Service Info

Renault ** - 228 0121 10 280/280 TGU6

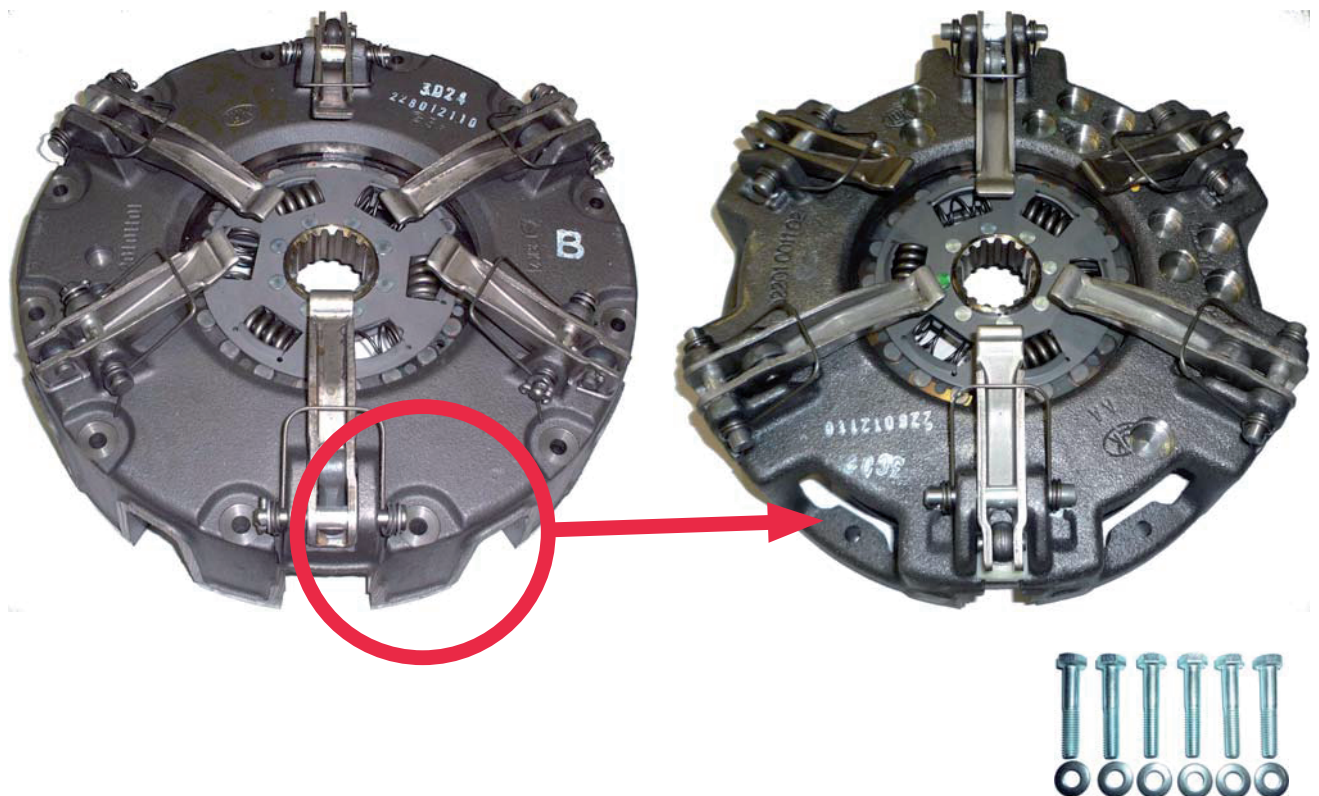
New design / Neues Design / Nouvelle conception / Nuevo diseño / Nuovo disegno

This new design utilises the latest clutch technology, using a vented housing for improved cooling and heat dispersal.

Fully interchangeable with existing clutches with no modifications required to the vehicle or flywheel.
New fixation bolt set 6 x M8 x 1.25 x 50mm is supplied with new designs to accommodate the lower housing.
